5440 WADE PARK BLVD, SUITE 102 WWW.BGEINC.COM NC LICENSE #C-4397 ©2023	DESIGNED BY:				
	DRAWN BY:				
	REVIEWED BY:		DF		
			DF/JWM	10/02/2023	PER TOWN OF ROLESVILLE COMMENT
				08/01/2023	PER TOWN OF ROLESVILLE COMMENT
		REV	06/01/2023	INITIAL SUBMITTAL

PARKER RIDGE
82 SCHOOL STREET
ROLESVILLE / NORTH CAROLINA / 27571

CARVED STREET CT PLAN
AND PROFILE

C6-4

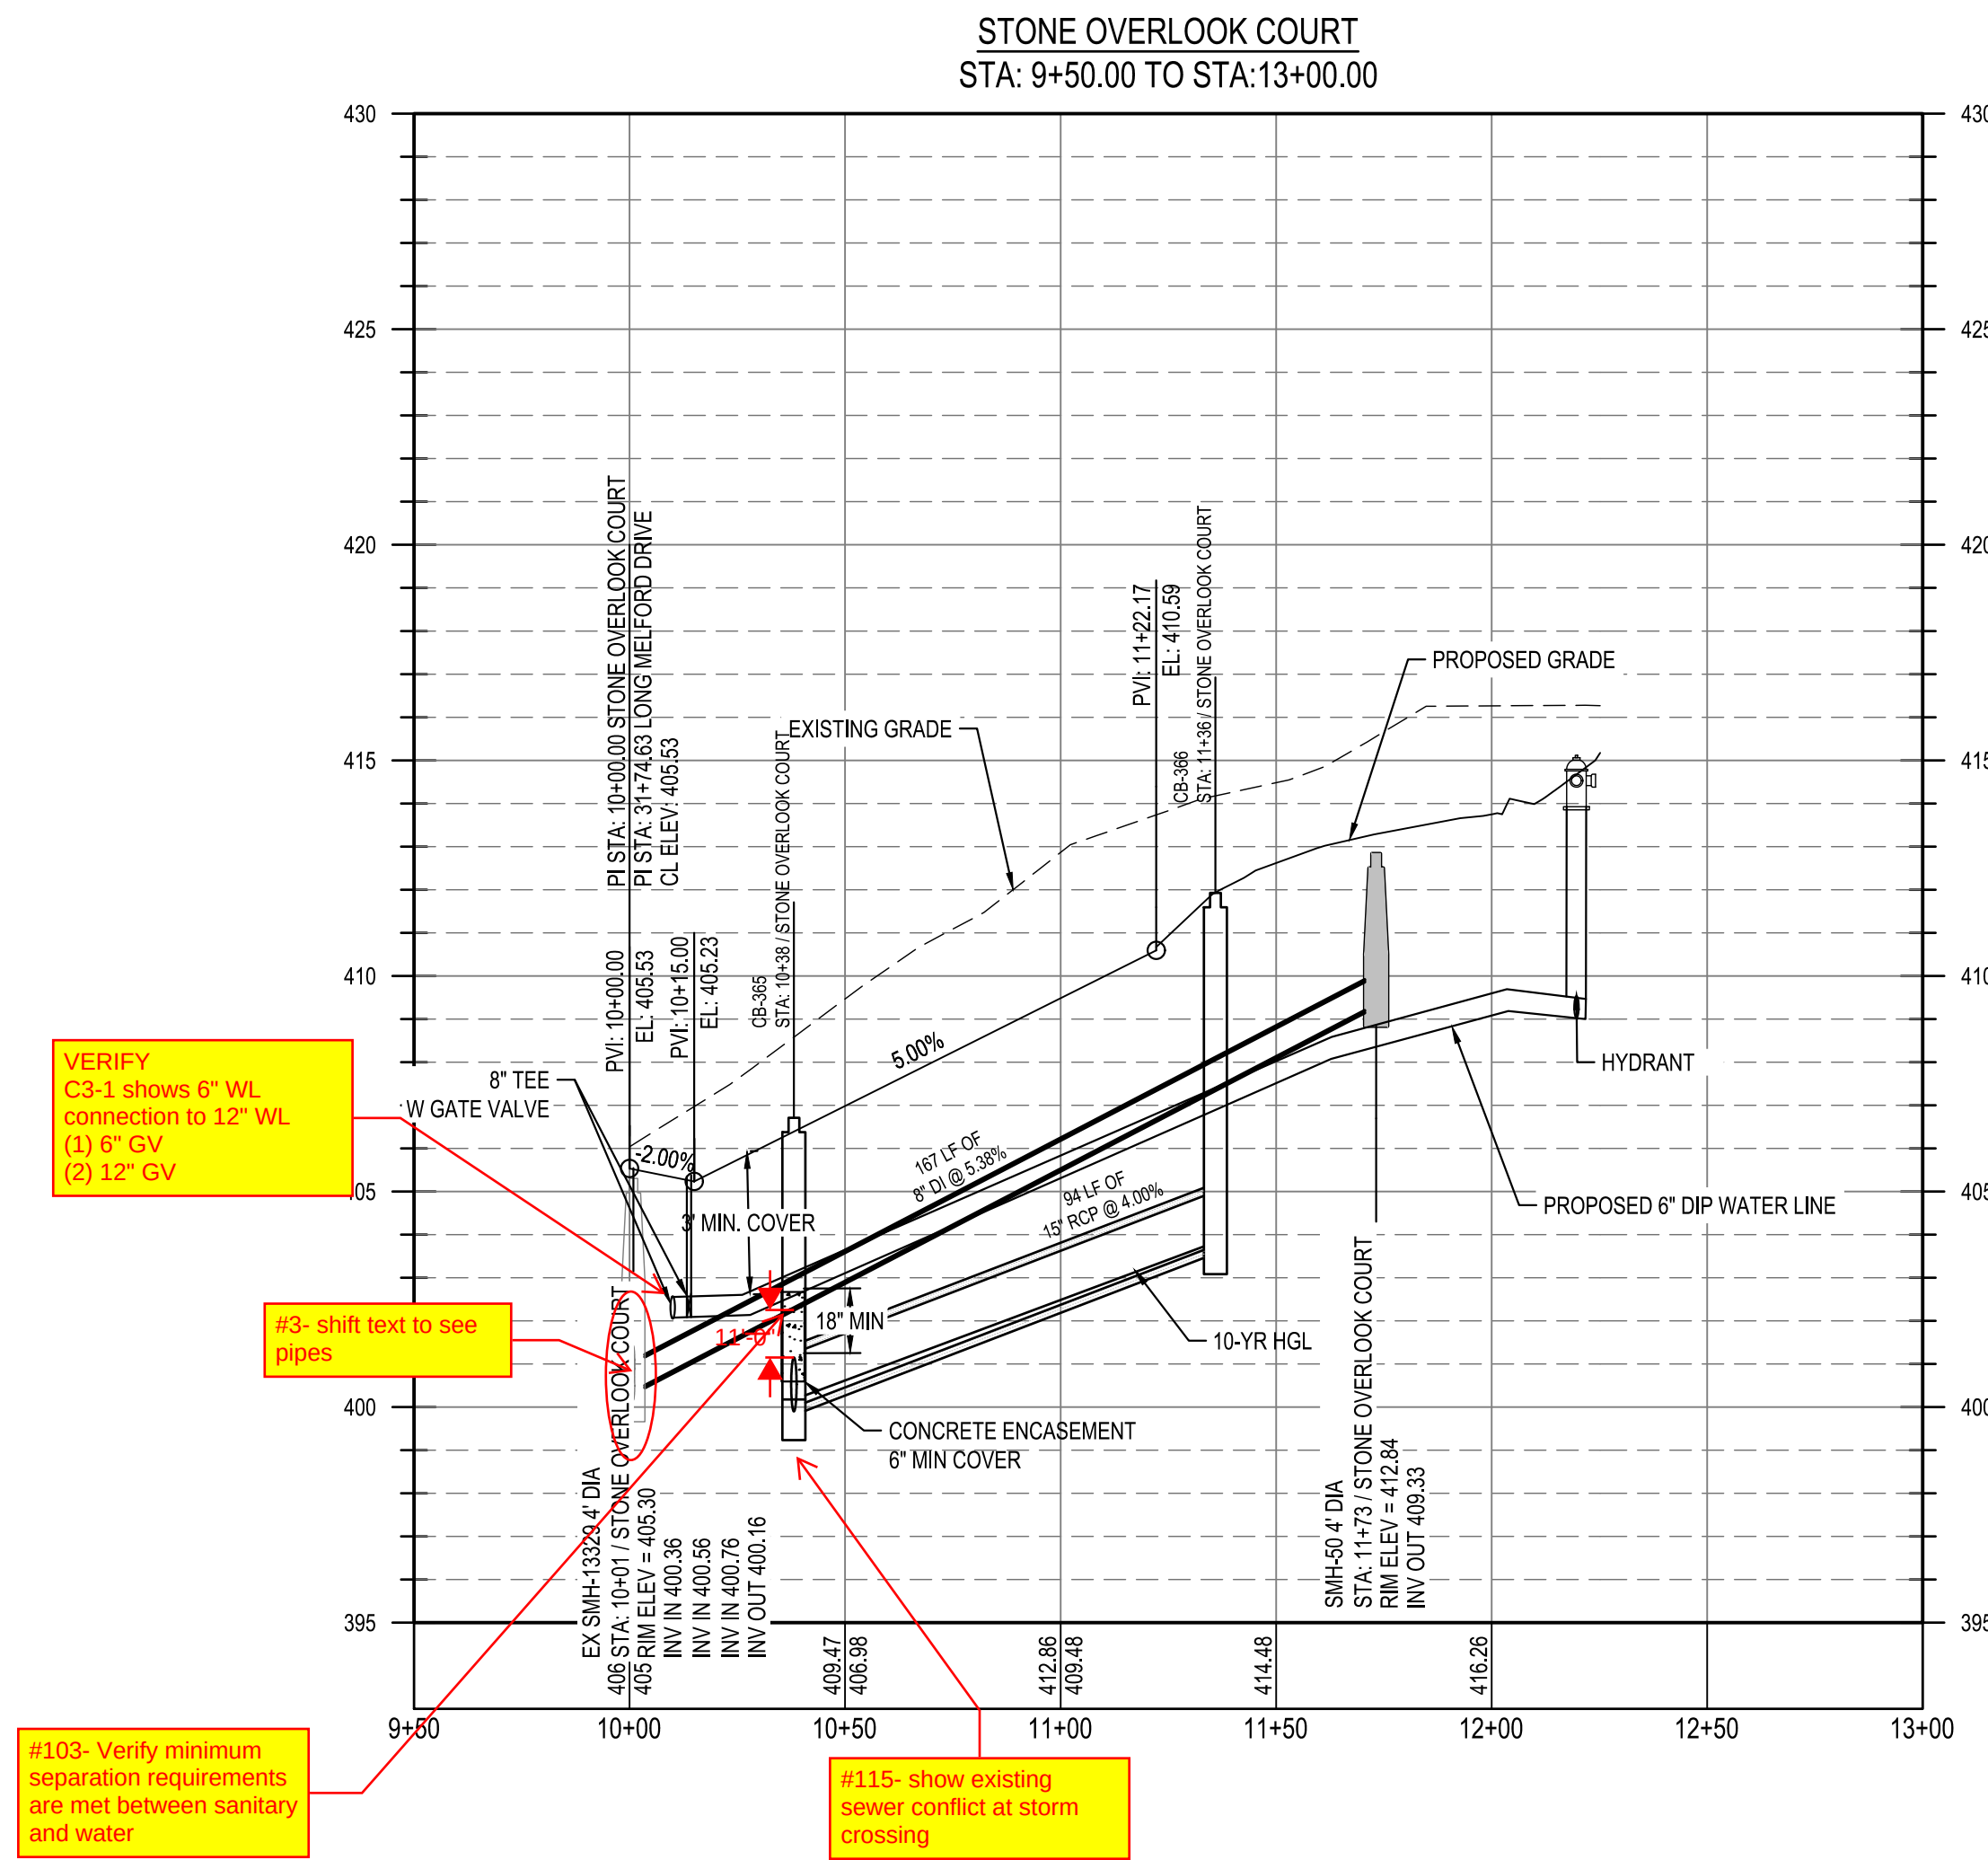
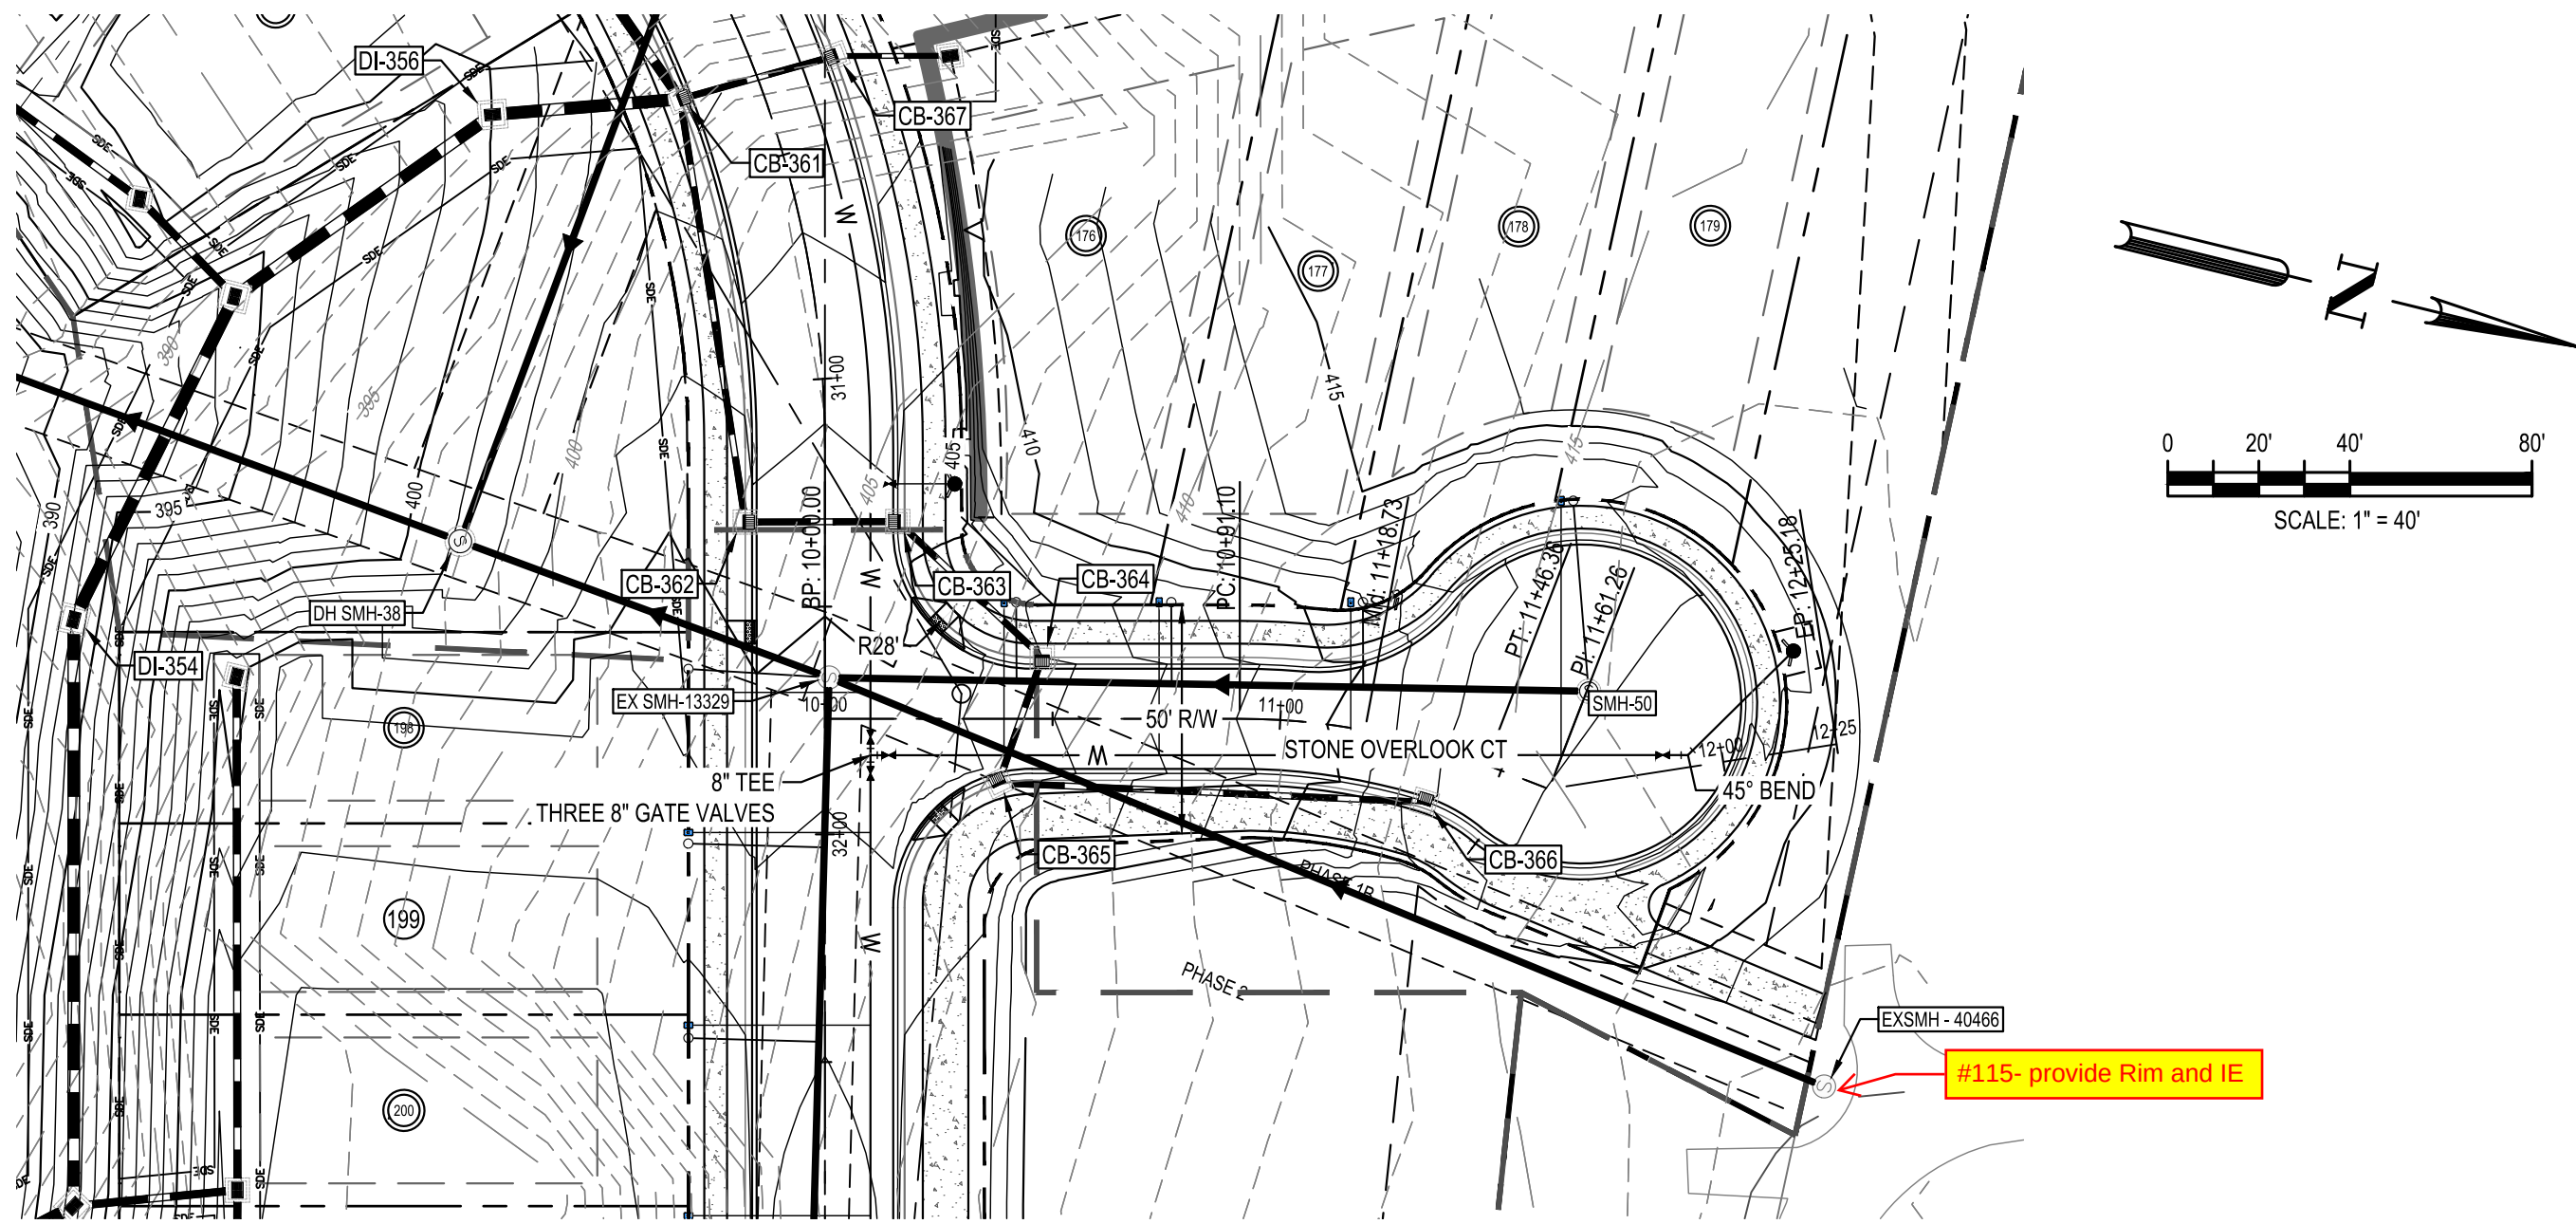
VERIFY
C3-1 shows 6" WL
connection to 12" WL
(1) 6" GV
(2) 12" GV

#3- shift text to see pipes

#103- Verify minimum separation requirements are met between sanitary and water

#115- show existing sewer conflict at storm crossing

#115- provide Rim and IE
